# **POWER AND WATER CORPORATION'S PROPOSED AMENDMENTS TO CODES - GENERATOR PERFORMANCE STANDARDS**

**FINAL DECISION**

*29 February 2020*

**Figure 9 – Inertia vs C-FCAS Trade Off Requirements for New Generators**

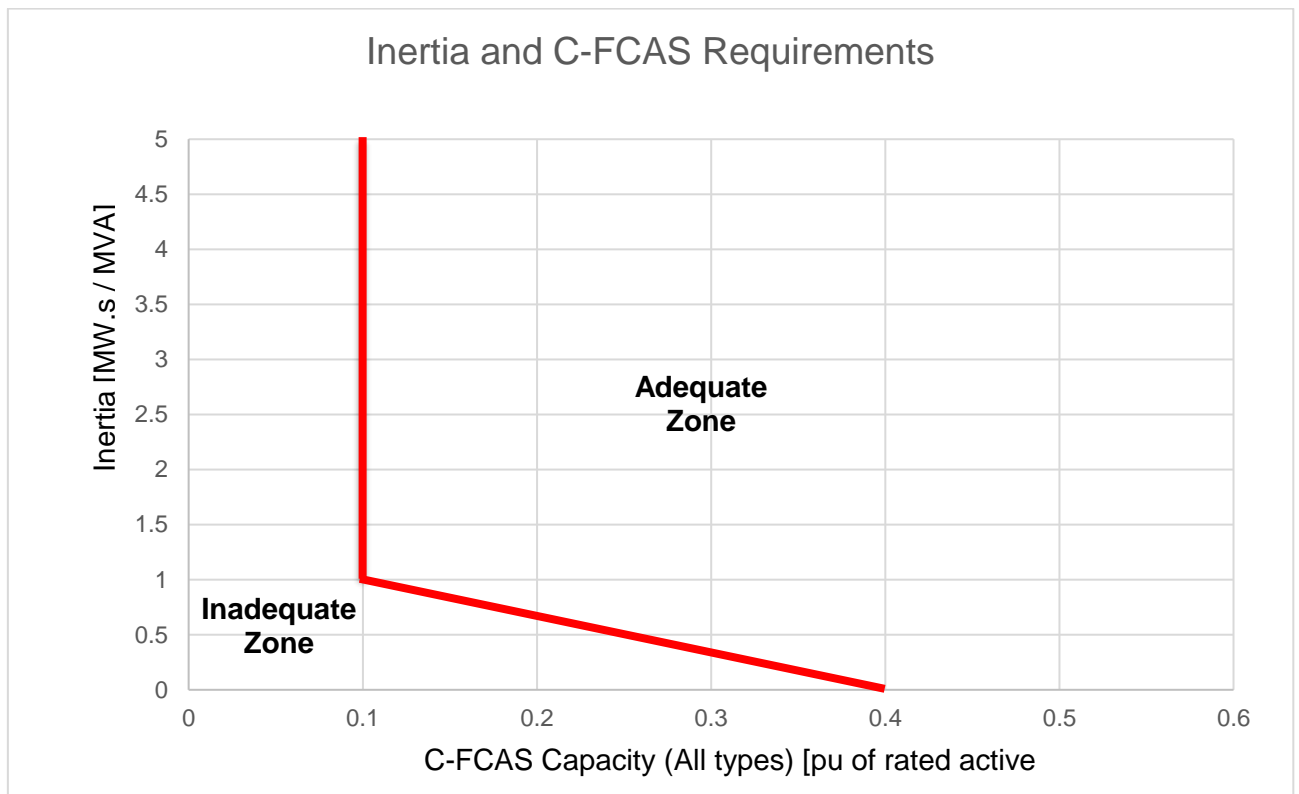
- (2) *Inertia* offered or provided from non-synchronous (emulated) sources needs to be assessed and accepted by the *Power System Controller* and *Network Operator*.

- (3) The *inertia* and *FCAS* capabilities will be accredited by the *Power System Controller* using the specifications and evaluation framework outlined in the System Secure Guidelines.

Figure 6.5: Forecasting accuracy, worst error

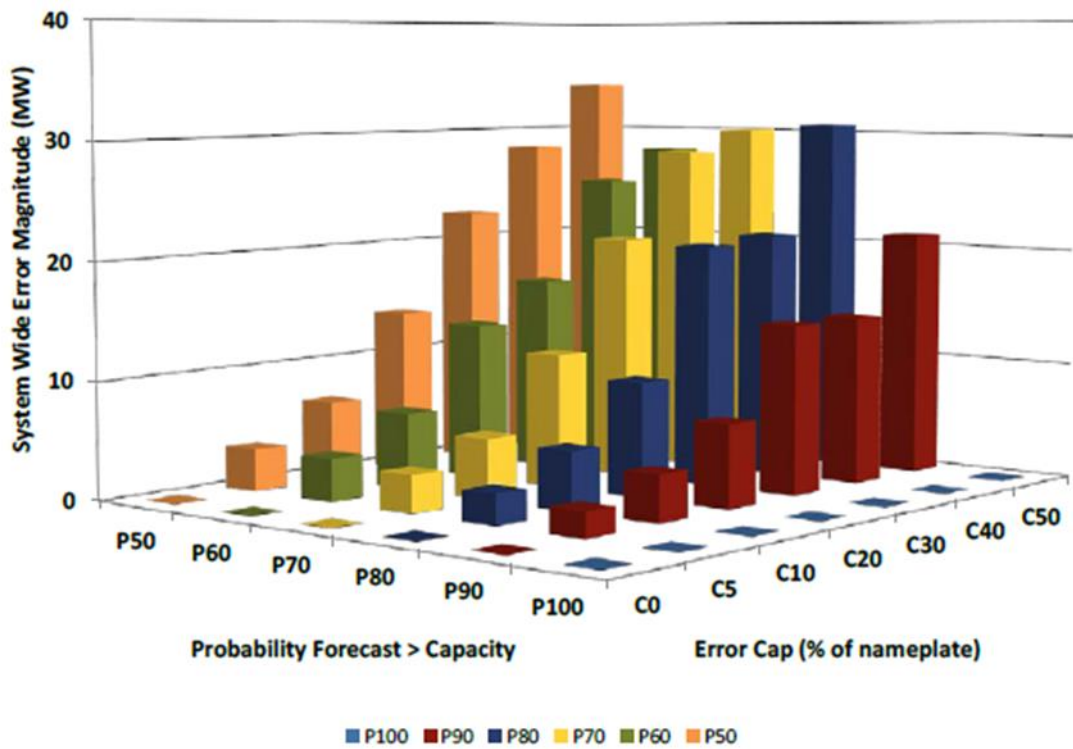
Figure 6.5 shows the system wide error that was simulated for different levels of solar forecast accuracy.

The proposed accuracy standard would deliver 90% of periods where forecast capacity is less than the actual capacity and a maximum error of 5% between the forecast and actual solar capacity. Table 2.1 indicates that forecast accuracy is estimated to breach the SSG about 1.5% of the time that solar generators are producing power. Figure 6.5 suggests the specified forecast accuracy will result in a system wide impact of a few MW.

Figure 4 - Power Supply / Demand Mismatch vs System Demand and Unregulated Frequency Impacts

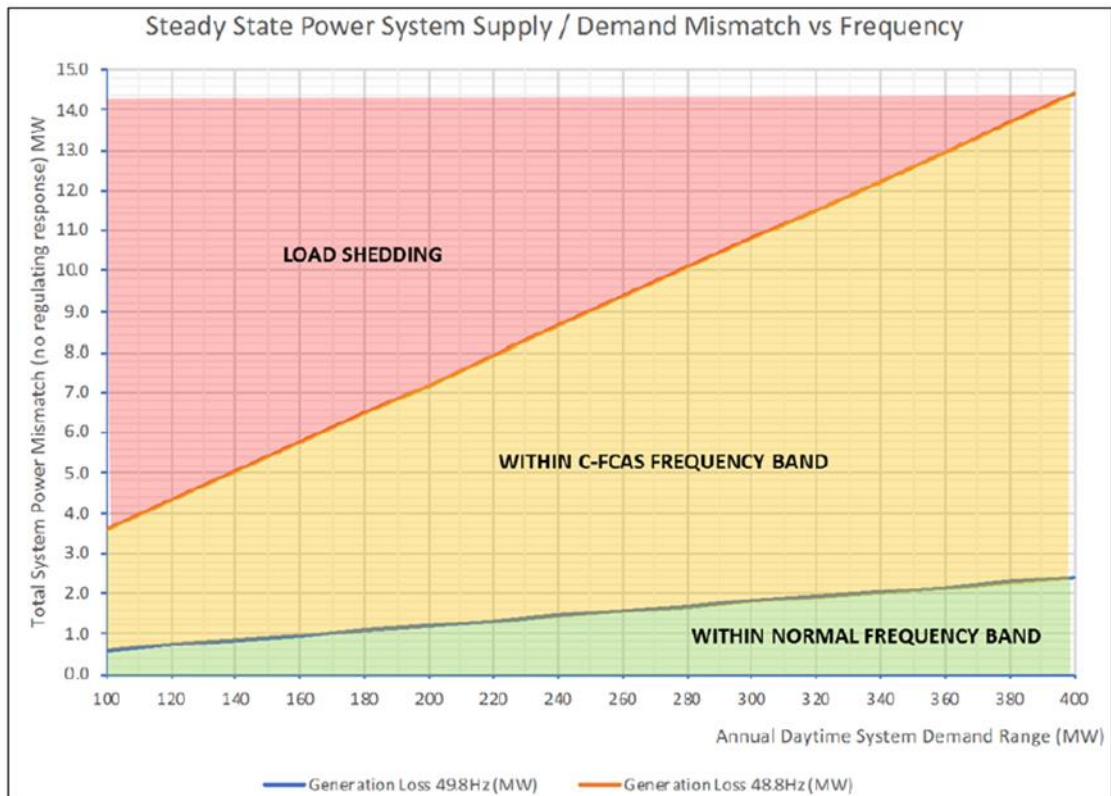
Figure 4 below was extracted from the supplementary consultation paper developed by PWC in March 2019, titled “Framework for the Future”. The figure presents an analysis of the size of imbalance between load and generation that could breach the frequency operating standard assuming no governor response. It shows that an imbalance of less than 3.75 MW in DKIS, with no governor response available should not give rise to load shedding. This means that a cloud cover event that causes a net generation reduction of less than 3.75 MW and occurs concurrently with a generator contingency should not give rise to load shedding. 3.75 MW aligns with the level of system wide error shown in Figure 6.5 for a solar forecast accuracy requirement achieving 90% of forecasts below the actual capacity and a maximum forecast error of 5%. This suggests that these accuracy requirements may be appropriate if cloud cover events are likely to align with generator contingencies in the Territory power systems.

The thermal generation fleet supplying the DKIS currently experience a high number of forced outages (98 occurred over a 12 month period in 2017-18). On that basis PWC have asserted that it is reasonable to assume cloud events and generator outage may occur at the same time. PWC appear to have assumed that the available governor response would be called upon to address the generator contingency and it is therefore necessary to limit the size of the forecast error due to a cloud cover event such that load shedding is not triggered assuming no governor response. This approach appears to be reasonable, as confirmed by
